MIL-S-19500/391C
AMENDMENT 2
30 June 1995
SUPERSEDING
AMENDMENT 1
6 May 1994

MILITARY SPECIFICATION

SEMICONDUCTOR DEVICE, TRANSISTOR, NPN, SILICON, LOW-POWER
TYPES 2N3019, 2N3019S, 2N3057A, AND 2N3700
JANTX, JANTXV, AND JANS

This amendment forms a part of MIL-S-19500/391C, dated 29 October 1993 and is approved for use by all Departments and Agencies of the Department of Defense.

FIGURE 1. Nonsaturated switching-time test circuit."

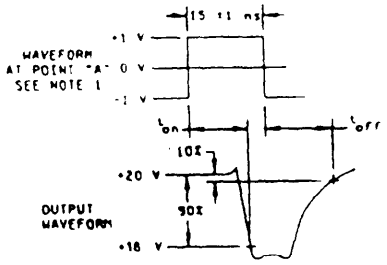
* FIGURE 1, delete and substitute as printed below:

NOTES:
1. The rise time ($t_r$) of the applied pulse shall be ≤ 2.0 ns, duty cycle ≤ 2% and the generator source impedance shall be 50 ohms.
2. Sampling oscilloscope: $Z_{IN}$ ≥ 100 kΩ, $C_{IN}$ ≤ 12 pF, rise time ≤ 2.0 ns.
